# Access Compliance Report

### (Curb Ramps)

Intersection ID: 3893	Main Street: DANIELLE CHRISTINA CT	Cross Street: OVERLOOK COVE RD	Location: NW
ADA ID: BAAECA58635E	Ramp Type: Perp	Initial Pass/Fail: Fail	Overall Compliance: No
Codes/Mitigation Info/Possible Solution		Field Measurements/Component Compliance	
Severity Score: 18.75

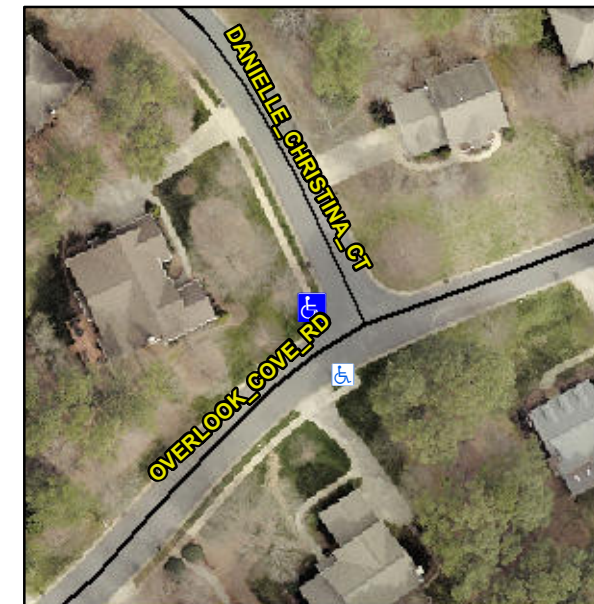
**Not Found, R304.5.1, R304.5.3**

Compliance	Description	Data	Compliance	Description	Data
N/A	Ramp Length (in)	100.0	Yes	Ramp Slope (%)	7.3
No	Ramp Width (in)	32.0	No	Ramp XSlope (%)	2.1
N/A	Flare Type LT	N/A	N/A	Flare Type RT	N/A
N/A	Flare Slope LT (%)	N/A	N/A	Flare Slope RT (%)	N/A
N/A	Flare Traversable LT?	N/A	N/A	Flare Traversable RT?	N/A
N/A	Landing Length (in)	N/A	N/A	DWS Provided?	N/A
N/A	Landing Width (in)	N/A	N/A	DWS Contrast?	N/A
N/A	Landing Slope (%)	N/A	N/A	DWS Length (in)	N/A
N/A	Landing X Slope (%)	N/A	N/A	DWS Full Width?	N/A
N/A	Landing Curb? (Y/N)	N/A	N/A	DWS Offset (in)	N/A
N/A	Shared Landing?	N/A			
N/A	Gutter Ponding?	N/A	N/A	Gutter Slope (%)	N/A
N/A	Gutter Lip Ht (in)	N/A	N/A	Gutter X Slope (%)	N/A
N/A	Painted X Walk1?	No	N/A	Painted X Walk2?	N/A
	X Walk 1 Direction	To S		X Walk 2 Direction	N/A
N/A	X Walk 1 Width (in)	N/A	N/A	X Walk 2 Width (in)	N/A
	X Walk 1 Slope (%)	0.3		X Walk 2 Slope (%)	N/A
	X Walk 1 X Slope (%)	1.7		X Walk 2 X Slope (%)	N/A

**Remove & Replace Entire Ramp.**
